Re: Response to El Paso County Review Comments
Monument Ridge East
Monument Hill Road and Palmer Divide Road
El Paso, Colorado
Entech Job No. 230248

Ref: Entech Engineering, Inc., revised date July 16, 2026. *Soils and Geology Study, Monument Ridge East, Monument Hill Road and Palmer Divide Road, El Paso County, Colorado.*
Entech Job No. 230248.

ENTECH ENGINEERING, INC. RESPONSES

PIEZOMETER MAP

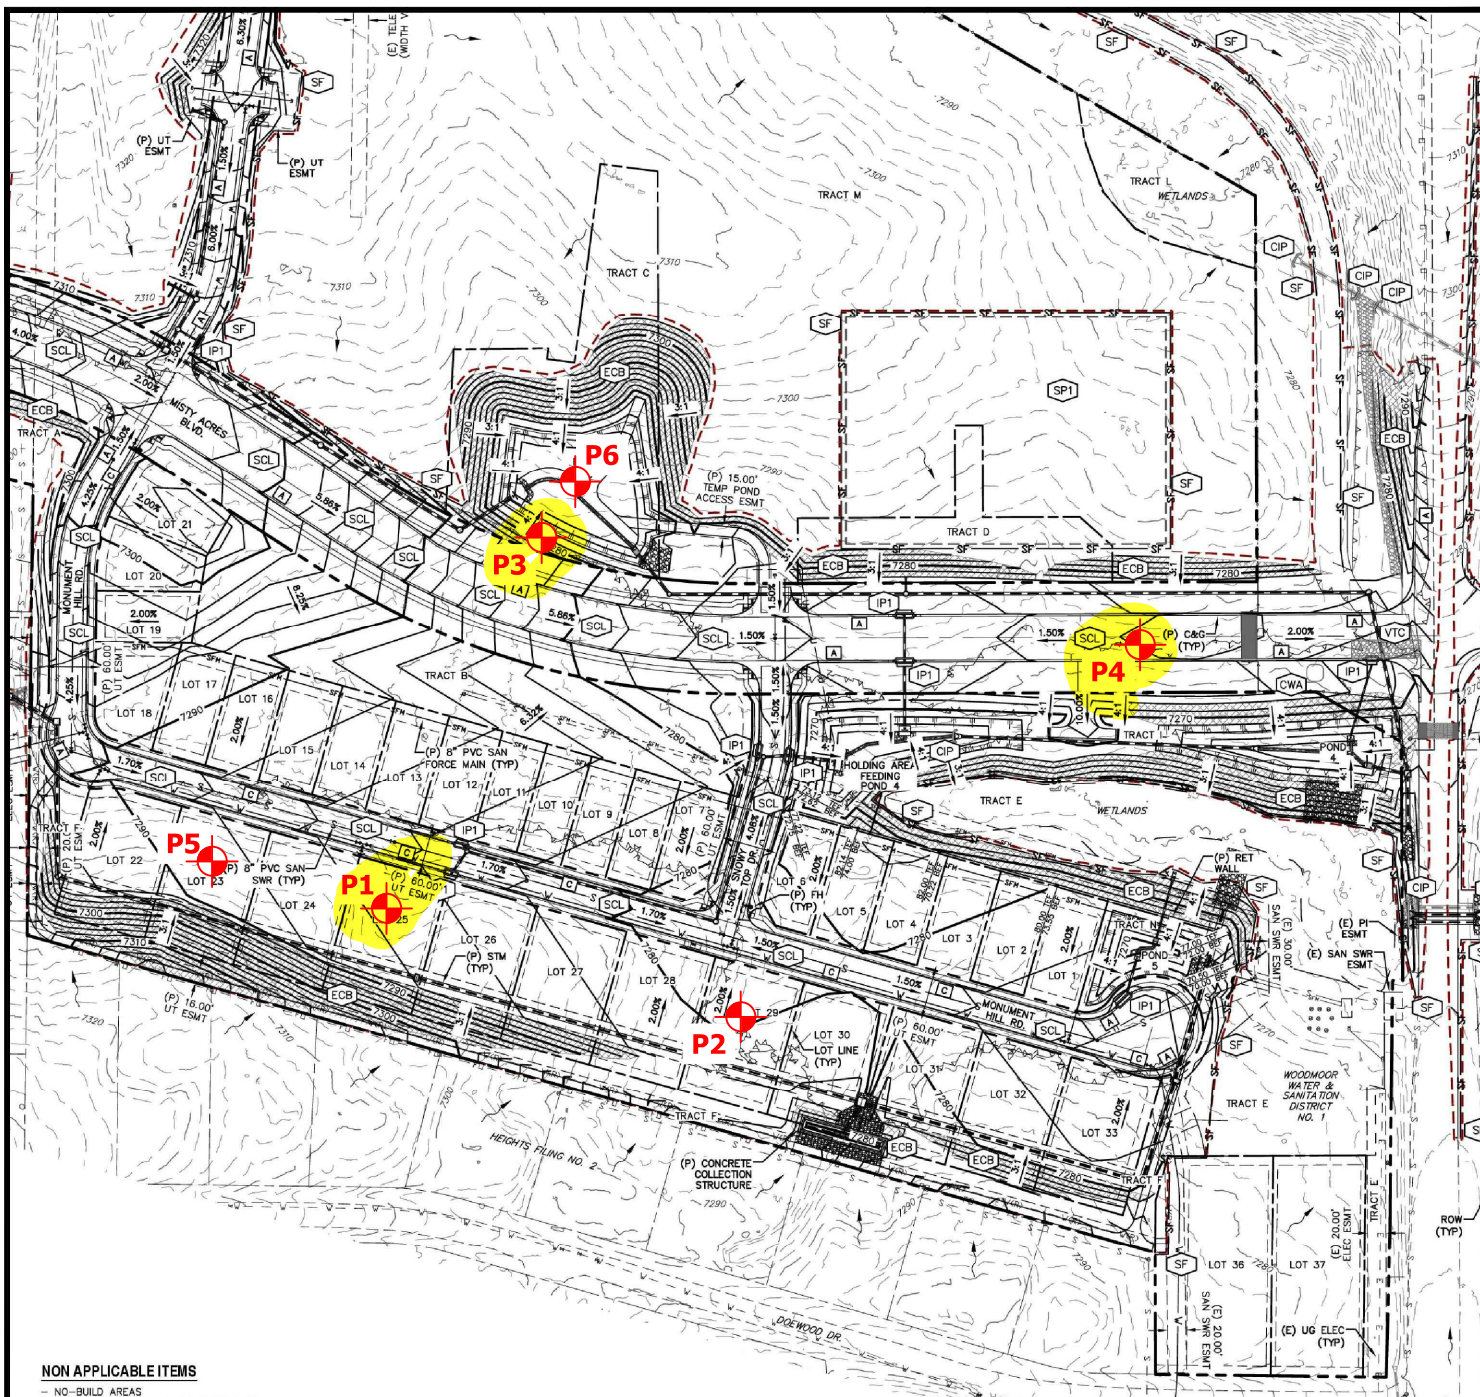
When will groundwater be determined for construction? Will testing be done prior to construction, early grading, or during construction? If groundwater is encountered within 5 vertical feet of public ROW or drainage facilities, additional reports and testing will be required to address shallow groundwater. (See ECM C.6.1)

The cut is deeper than
the groundwater where
highlighted

Entech installed two additional piezometers on July 21, 2026 (P5 and P6). P5 was placed on proposed Lot 23, and P6 was placed in the bottom of Pond 2. The locations of the piezometers for the site are shown in the Piezometer Map, Figure 1. The test boring logs for the two additional piezometers are included in Appendix A, and Laboratory Testing Results are included in Appendix B. Piezometer readings for the development are included in Exhibit 1.
